UNITED STATES PATENT AND TRADEMARK OFFICE

APPLICATION NO.	FILING DATE	FIRST NAMED INVENTOR	ATTORNEY DOCKET NO.	CONFIRMATION NO.
10/724,387	12/01/2003	John W. Rohan-Weaver	ROHAN-WEAVER Pure Swing	9659
7590	07/28/2004		EXAMINER	
Julian C. Renfro, Esquire P.O. Box 2601 Winter Park, FL 32790-2601			LEGESSE, NINI F	
			ART UNIT	PAPER NUMBER
			3711

Office Action Summary

DETAILED ACTION

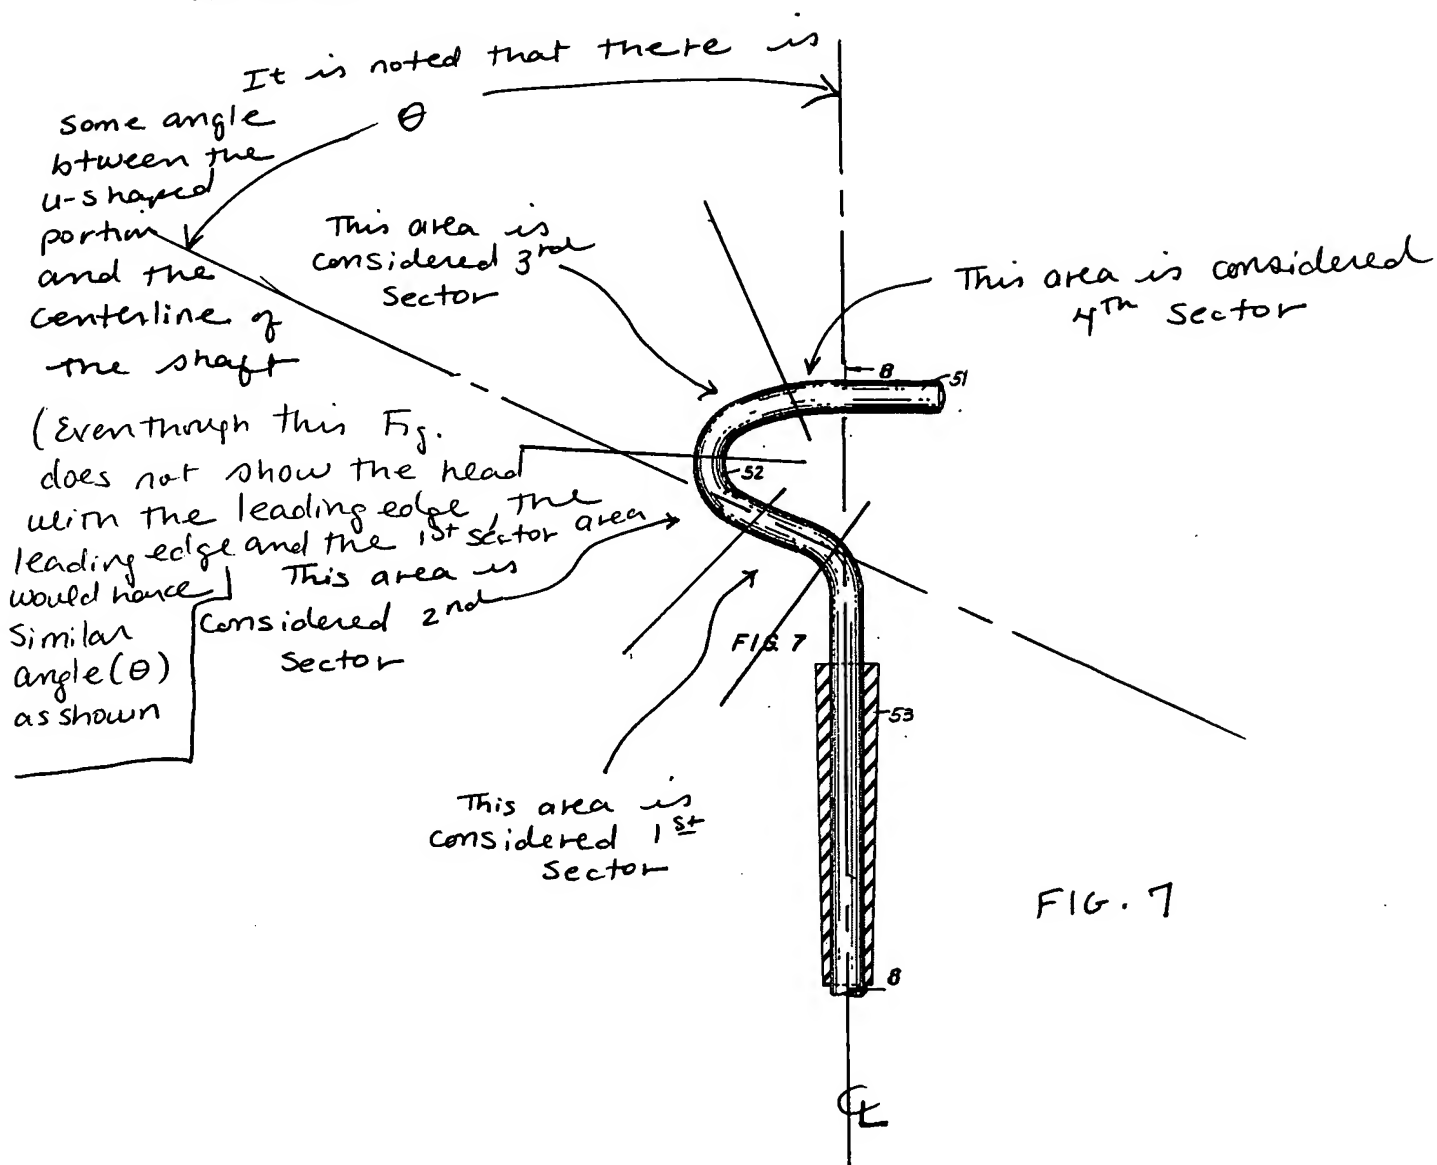
- **With respect to claims 3, 7 and 14**, the upstanding curved portion/U-shaped portion is made up of four separate sectors (see the marked up Figure provided below).

In order to clarify the Examiner's broad interpretation of the claims that are rejected by the Schneller (US Patent No. 5,127,650) reference, mark up drawing of Fig. 7 of this reference is presented below.
